Idaho Technical Guidance Committee

Meeting Agenda

Thursday, March 5, 2026

TGM Figure 2-8 Cutoff trench plan view (**Appendix C**)

Figure 2-8. Cutoff trench plan view.

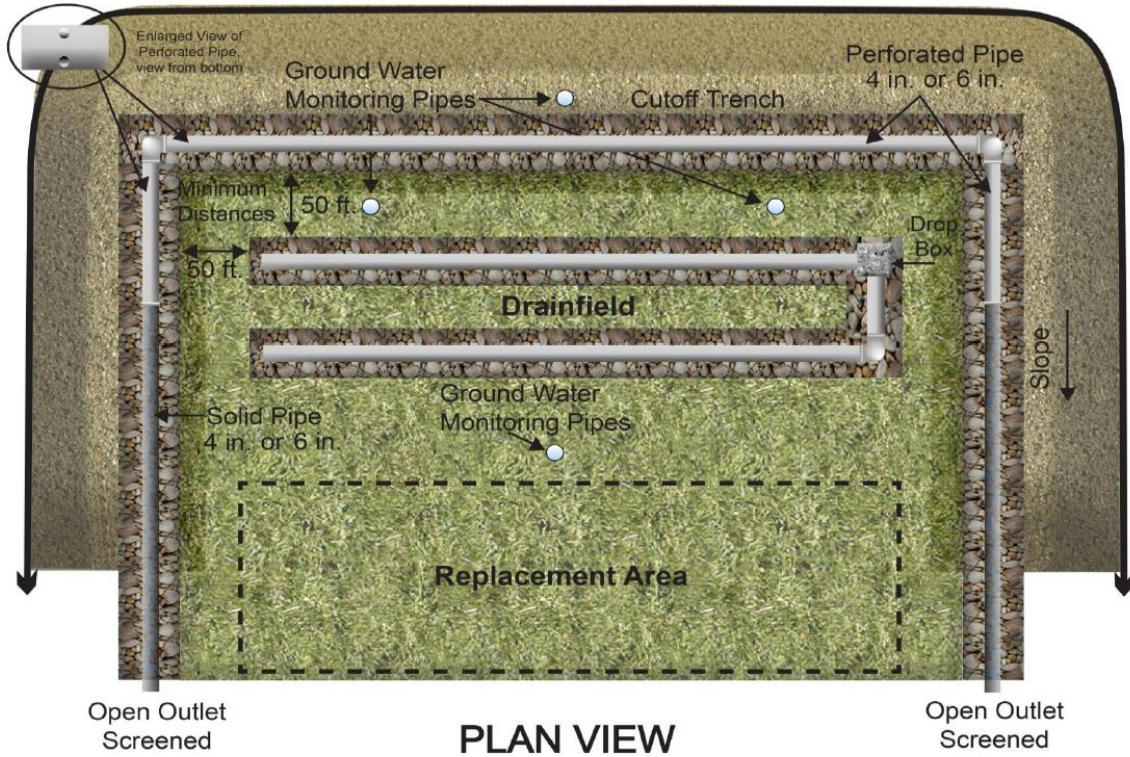
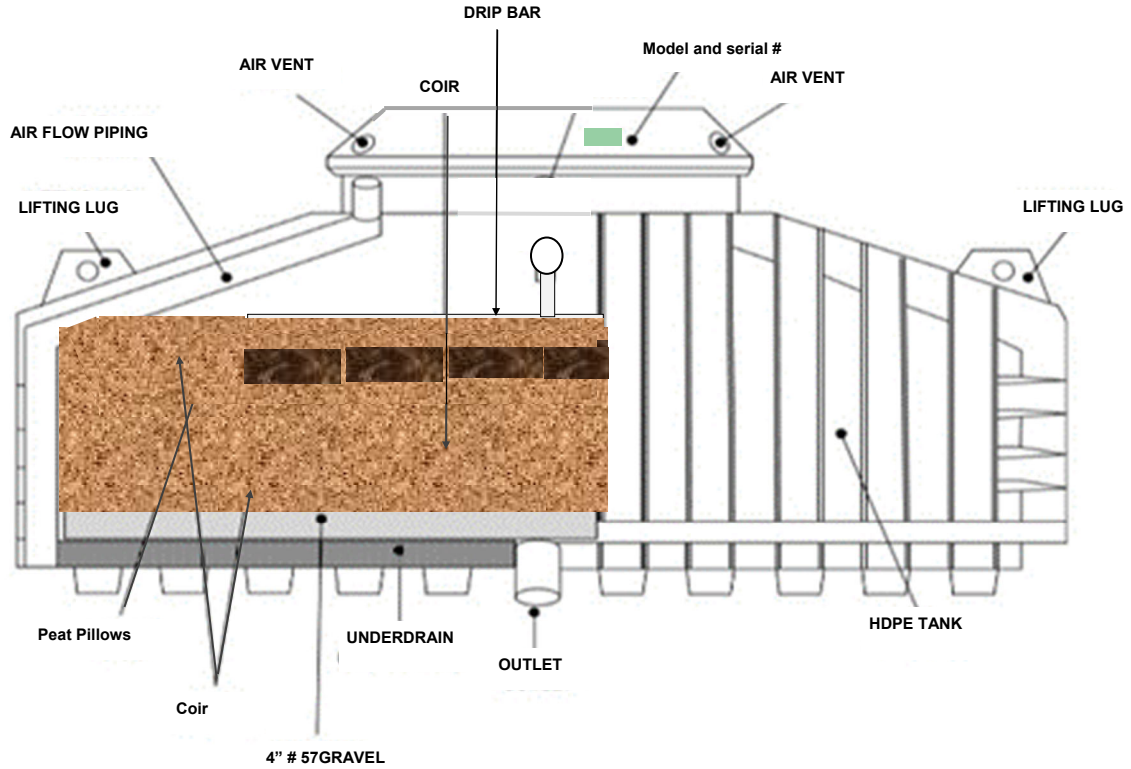
- Revise Figure 2-8 to delete the 50-foot minimum separation distance depicted in the figure. The minimum separation distance from the drainfield to a cutoff trench is determined by Table 2-12 and varies from 9.5 feet to 120 feet.
- Revisit proposed edits.
- Vote on action

- Revise Figure 2-8 to delete the 50-foot minimum separation distance depicted in the figure. The minimum separation distance from the drainfield to a cutoff trench is determined by Table 2-12 and varies from 9.5 feet to 120 feet.
- Jason appreciates the edit, and it has created confusion in the past.
- Peter said it will be posted for public comment.
- Vote on preliminary approval.
